Reference: City of Ottawa comments in the letter dated March 14, 2025 concerning file numbers D02-02-24-0084 & D07-12-24-0177 subject “Feedback Form: Completeness Review (2) Minor Zoning By-law Amendment and Site Plan Control Complex 73, 79 and 83 Ste-Cecile Street”.

Subject: response to the referenced comments following the meeting with C of O staff completed on March 20, 2025.

SUBSURFACE INVESTIGATION REPORT

73, 79 AND 83 STE CECILE ST., OTTAWA, ON, K4A 3N6

Figure 2: Factor of safety of proposed open cut

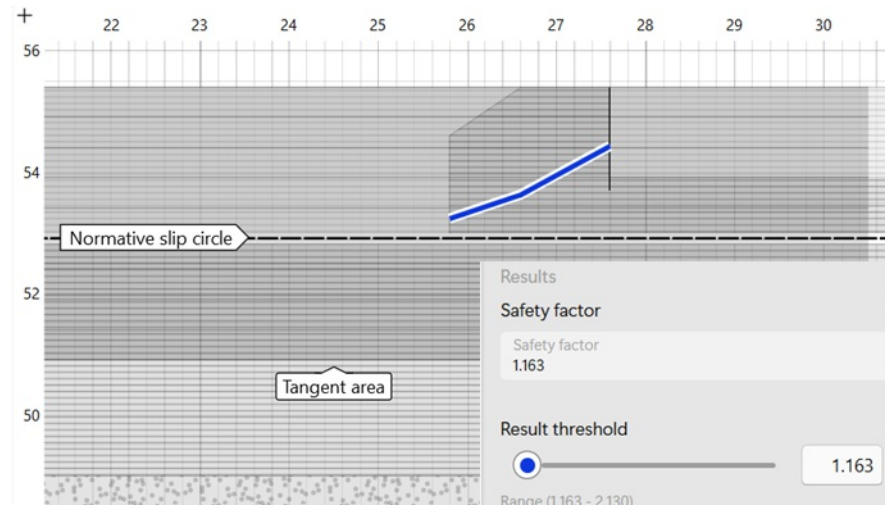
7. i) j) and k)
 - No further action is required once the items above have been addressed.
8. item l. “Although the design of the shoring system is the contractor’s responsibility, the report should still provide mechanical soil properties (unit weight, friction angle, and active/passive earth pressure coefficients) for each soil layer. Additionally, this section should include a more detailed discussion on the site surroundings, setbacks on each side, and anticipated shoring requirements for each boundary.”

- A material properties table has been added to the subsurface materials section. We added an analysis to this section to assess the need of shoring for 2.5 m maximum excavation depths given the materials and the geometry of cuts along the nearest property line.

At this site a preliminary slope stability analysis was completed to examine the need for shoring excavation depths above the water table. The analysis shows that for the geometry shown in fig. 2 in page 15, which applies to the closest property line with 87 Ste. Cecile St., a factor of safety of 1.16 applies to excavations 2.5 m or shallower.
